- Subject** ▶ Change on Compression Spring 39 which prevents the machine from losing blow
- For Models** ▶ HM1100C, HM1100 (Demolition Hammers)
- Description** ▶ As illustrated below, the thickness and number of turns of Compression Spring 39 have been changed.

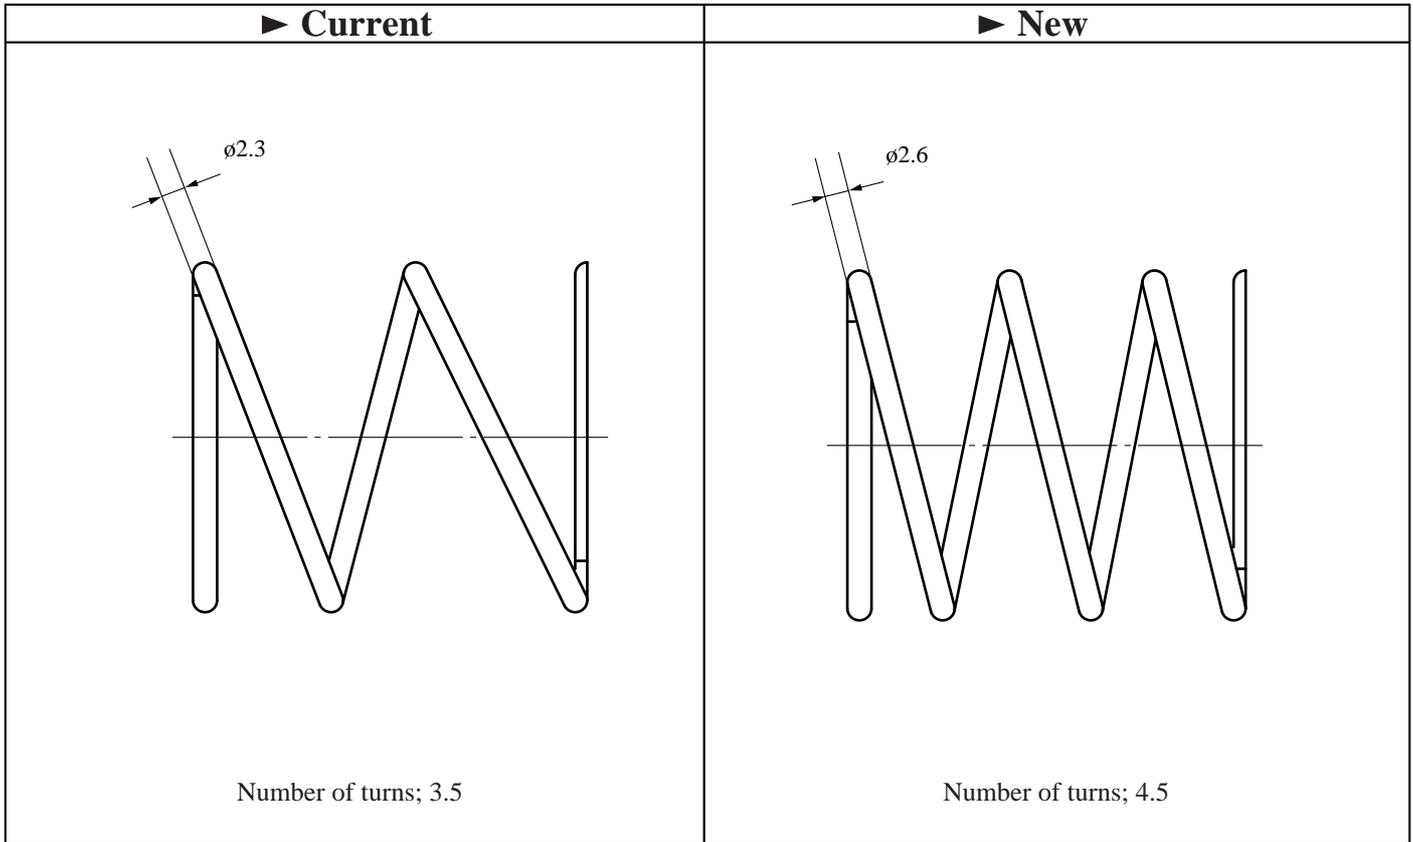
The new one is increased in number of turns and in thickness of wire compared to the current one for more strength.

Item No.	Current part		Q'ty	I/C	New part		Q'ty	Note
31	Compression Spring 39 233166-3		1	<=	Compression Spring 39 233190-6		1

HM1100C: From serial No. 4354E  
 HM1100: From serial No. 1248E
